DC-10

SERVICE BULLETIN

BULLETIN 54-48

NACELLES/PYLONS - Attach Fittings - Replace Engines 1 And 3 Wing Pylon Aft Attach Spherical Bearings.

ENGINES 1 AND 3 WING PYLON AFT ATTACH BEARINGS - REPLACEMENT

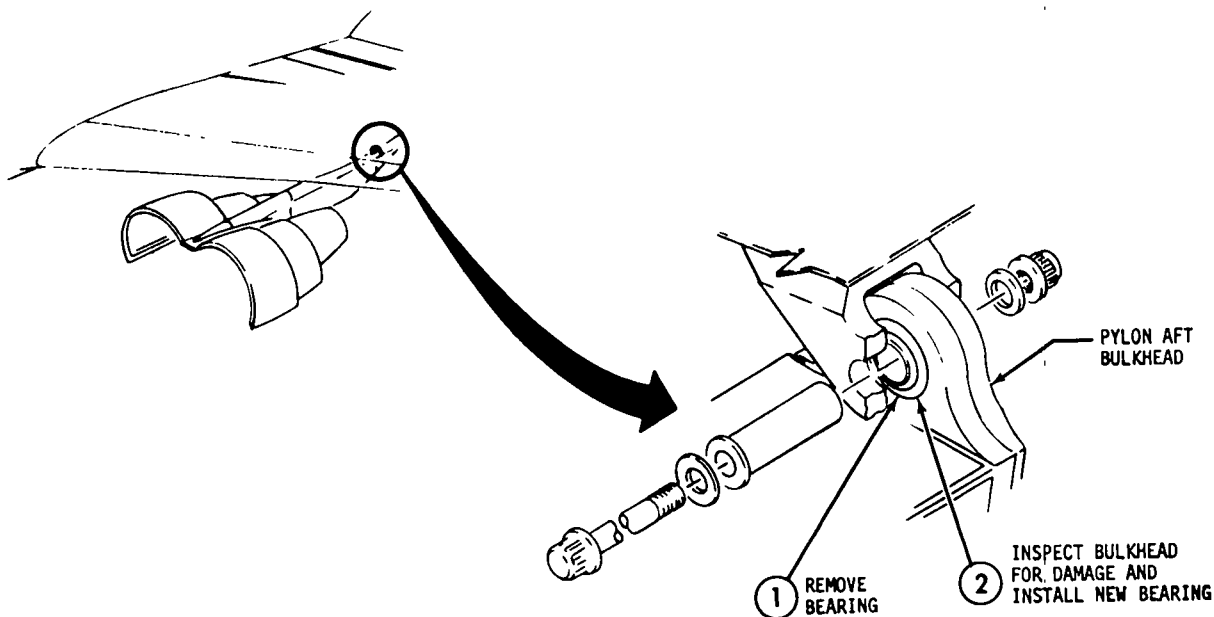
- 1 REMOVE KSBY22N1, ATBY22V4, BLFR22-034, YTA301, 76689, LHSS22-77, LHSSR22-77, OR KSBY22-2 BEARING USING DZZ7237-1 WING PYLON AFT BEARING REMOVAL SET TOOLS AND HP-60G ENERPAC PUMP AND CYLINDER SET. (SEE MAINTENANCE MANUAL CHAPTER 54-00-00, PARAGRAPH ENTITLED "REMOVE PYLON", STEP 43b.)
- 2 VISUALLY INSPECT BULKHEAD FOR EVIDENCE OF DAMAGE DUE TO GOUGING OF BEARING INTO BULKHEAD AND ACCOMPLISH THE FOLLOWING:
 - a. IF DAMAGE IS NOT EVIDENT, MEASURE HOLE IN BULKHEAD. IF HOLE SIZE IS 2.9985/2.9990(76.1619/76.1746)-INCH DIAMETER INSTALL NEW KSBY22-5, BSSR-22220, NSS220, OR 79583 BEARING USING DZZ7237-1 WING PYLON AFT BEARING TOOLS AND HP-60G ENERPAC PUMP AND CYLINDER SET. (SEE MAINTENANCE MANUAL CHAPTER 54-00-00, PARAGRAPH ENTITLED "REMOVE PYLON", STEP 43c.)

NOTE: IF HOLE SIZE IS GREATER THAN 2.9990(76.1746)-INCH DIAMETER, OVERSIZE BEARING MUST BE INSTALLED PER STEP 2b.

- b. IF DAMAGE IS EVIDENT OR HOLE SIZE EXCEEDS 2.9990(76.1746)-INCH DIAMETER, ENLARGE HOLE IN BULKHEAD IN INCREMENTS NOTED AS REQUIRED TO CLEANUP DAMAGE, CHAMFER BOTH HOLE EDGES .045+.010(1.143+.254) X 45° USING APPLICABLE REAMER AND CUTTER FROM DZZ7244-1 "C" TOOL SET. SEE TABLE 1. (SEE MAINTENANCE MANUAL CHAPTER 54-00-00, PARAGRAPH ENTITLED "REMOVE PYLON.")

NOTE: OVERSIZE BEARING TO BE USED ONLY WHEN DAMAGE IS EVIDENT OR HOLE IN BULKHEAD EXCEEDS 2.9990(76.1746)-INCH DIAMETER.

FINAL HOLE SIZE	REAMER	CUTTER	APPLICABLE BEARING
3.0005/3.0010 (76.2127/76.2254)	DZZ7244-29	DZZ7244-35	KMS1005 (.002(.0508)-INCH OVERSIZE)
3.0085/3.0090 (76.4159/76.4286)	DZZ7244-31	DZZ7244-37	KMS1006 (.010(.2540)-INCH OVERSIZE)
3.0185/3.0190 (76.6699/76.6826)	DZZ7244-33	DZZ7244-39	KMS1007 (.020(.5080)-INCH OVERSIZE)
3.0285/3.0290 (76.9239/76.9366)	DZZ7244-3	DZZ7244-5	KMS705 (.030(.7626)-INCH OVERSIZE)
			OR
			LH22F
			OR
			79828
